Product Change Notification

Product Change #: PCN311

Posting Date: October 6, 2015

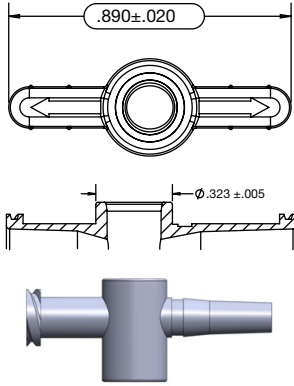
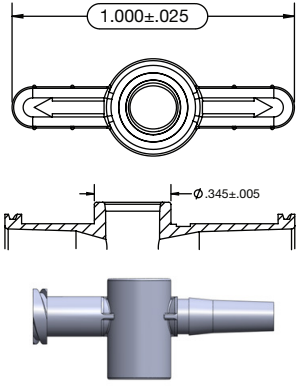
Assemblies Affected	Change Description	Before Image	After Image
CA260-001	Component Body: The outer diameter of the grip and tolerance is being adjusted from 0.205 +/- 0.005" to 0.226 +/- 0.005" to accommodate tooling draft and ejector sleeve diameter.	 $\phi 0.205 \pm 0.005"$	 $\phi 0.226 \pm 0.005"$
CA261-001	Component Body: The outer diameter of the grip and tolerance is being adjusted from 0.260 +/- 0.005" to 0.226 +/- 0.005" to accommodate tooling draft and ejector sleeve diameter.	 $\phi 0.260 \pm 0.005"$	 $\phi 0.226 \pm 0.005"$
FCFM-2A-004 FCFM-2A-005 FCFMR-2A-004	Diverter: No change Body: The side ports will have core outs to prevent sink on the ID.		
FCA025-001 FCFM-001 FCFM-002 FCFM-006 FCFMR-001	Diverter: No change Body: We are increasing the OD of the body barrel to 0.345 +/- 0.005" to match VP standards. The side ports will have core outs to prevent sink on the ID.	 	 
FCHPFMR-002 FCHPFMR-003 FCHPFMR-005	Diverter: Increase the length of the diverter handle to 1.000 +/- 0.025" to match VP standards. Body: The side ports will have core outs to prevent sink on the ID.

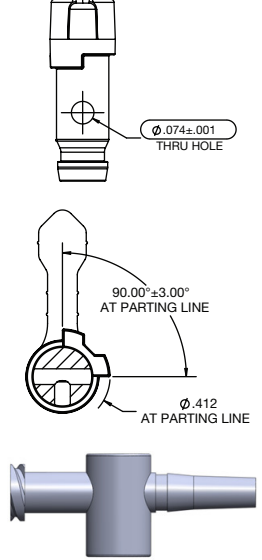
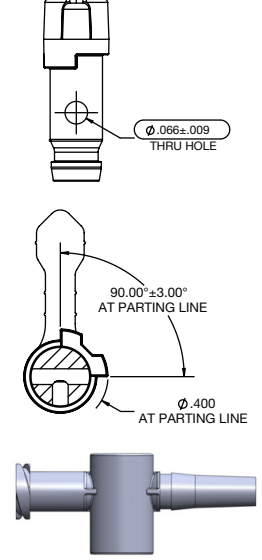
FCA021-001	Diverter: Increase the length of the diverter handle to 1.000 +/- 0.025" to match VP standards. Body: No changes	 	 
FCHPFFMR-001 FCHPFFMR-002	Diverter: A gate pad recess will be added to match the FCD1A001 gate pad recess, so the steel can be shared between the two SKUs Body: The side ports will have core outs to prevent sink on the ID.

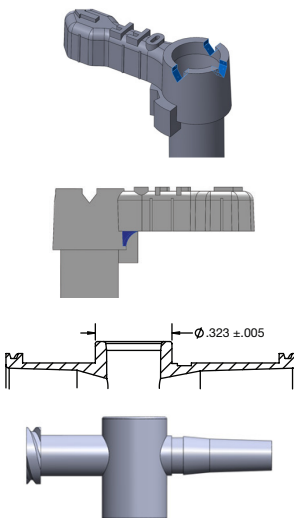
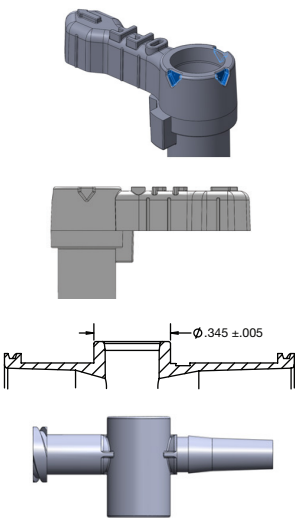
Assemblies Affected	Change Description	Before Image	After Image
FCFM-010	<p>Diverter: Increase the length of the diverter handle to 1.000+/- 0.025" to match VP standards.</p> <p>Body: We are increasing the OD of the body barrel to 0.345 +/-0.005" to match VP standards. The side ports will have core outs to prevent sink on the ID.</p>		
FC4FFMR-001 FCA024-001 FCA024-002 FCFFM-002 FCFFM-1A-003	<p>Diverter: Flow direction indicator notches on the top of the diverter are causing flash, we will be adding a web to that feature. We will be removing a radius on the bottom of the handle as it creates a sharp feature on other parts since the steel is shared with other diverter SKUs.</p> <p>Body: The side ports will have core outs to prevent sink on the ID.</p>		
FCA022-001	<p>Diverter: The through bore tolerances will be adjusted to 0.066 +/- 0.009" to match VP large bore standards. Reduce diameter of gate pad/rotation stop to 0.400 +/- 0.005" to match VP standards.</p> <p>Body: The side ports will have core outs to prevent sink on the ID.</p>

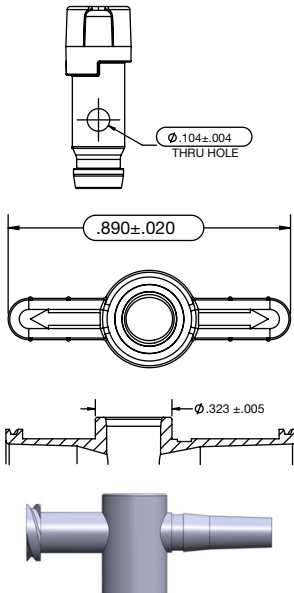
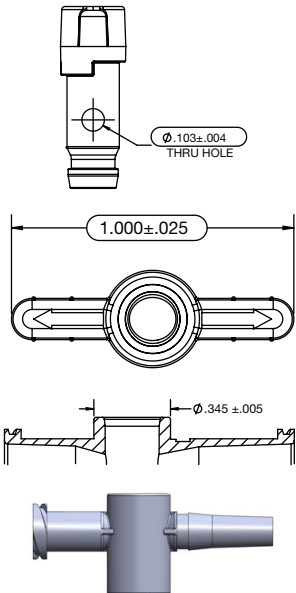
Assemblies Affected	Change Description	Before Image	After Image
FCA010-001 FCA012-001 FCA026-001 FCA028-001 FCA040-001 FCA047-001 FCFFM-003 FCFFM-008 FCFFM-009 FCFFM-010 FCFFM-013 FCFFM-014 FCFFMR-002 FCFFMR-003 FCFFMR-004	<p>Diverter: Flow direction indicator notches on the top of the diverter are causing flash, we will be adding a web to that feature. We will be removing a radius on the bottom of the handle as it creates a sharp feature on other parts since the steel is shared with other diverter SKUs.</p> <p>Body: We are increasing the OD of the body barrel to 0.345 +/-0.005" to match VP standards. The side ports will have core outs to prevent sink on the ID.</p>		
FCA019-001 FCLBFMR-001	<p>Diverter: The through bore tolerances will be adjusted to 0.103 +/- 0.004" to match VP large bore standards. Increase the length of the diverter handle to 1.000 +/- 0.025" to match VP standards.</p> <p>Body: We are increasing the OD of the body barrel to 0.345 +/-0.005" to match VP standards. The side ports will have core outs to prevent sink on the ID.</p>
